Source: Prestolite Electric Heavy Duty Systems
Date: 25/05/05
Subject: Introduction of the AS128eHD
Bulletin No: TSB4005
Models: A55, LNA55 & AC5

Technical Service Bulletin

Bulletin No TSB4005

AS128eHD Alternator

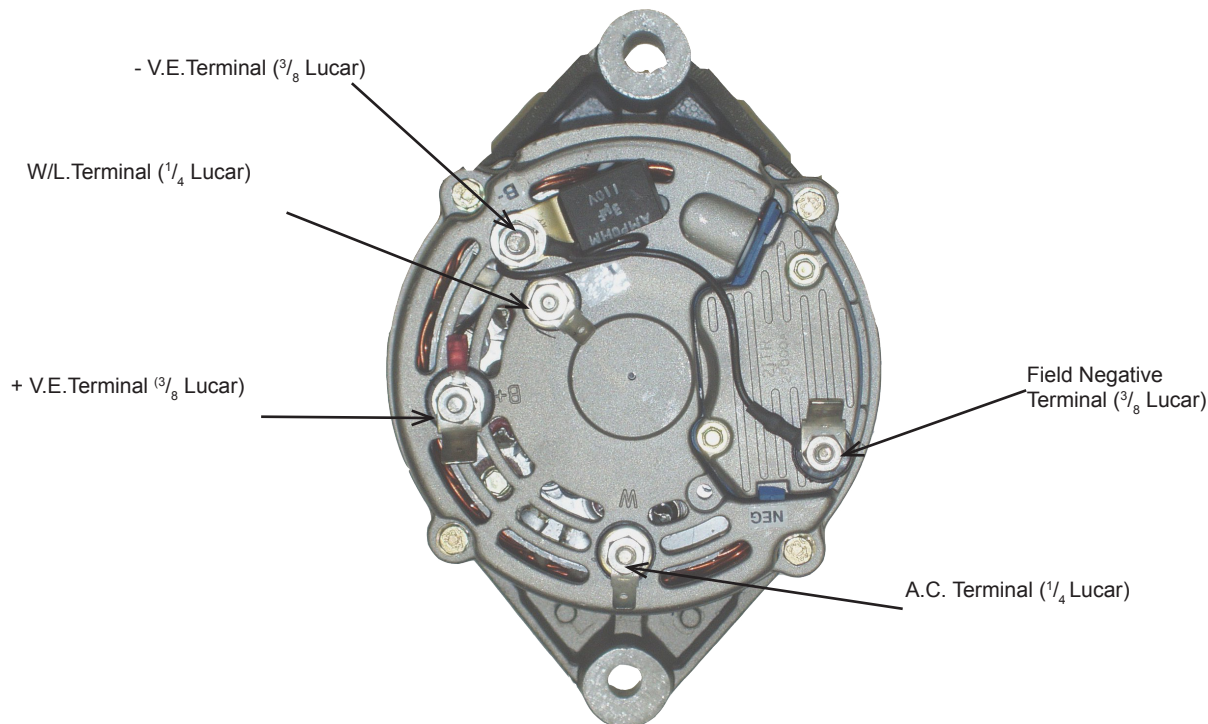
The AS128e can be used to replace any of the alternators shown on the previous page. Please ensure that the wiring connections are made to the correct terminals.

+V.E. Terminal	Battery positive
- V.E. Terminal	Battery Negative
Field Negative Terminal	The Field Negative terminal is for use with the field isolation function on some vehicles with battery isolation. The link wire should be removed if this function is required.
W/L Terminal	Used to drive the vehicle warning light circuit load must not exceed 1Amp
A.C. Terminal	Provides an A.C. output which can be used to drive a rev counter. load must not exceed 1Amp
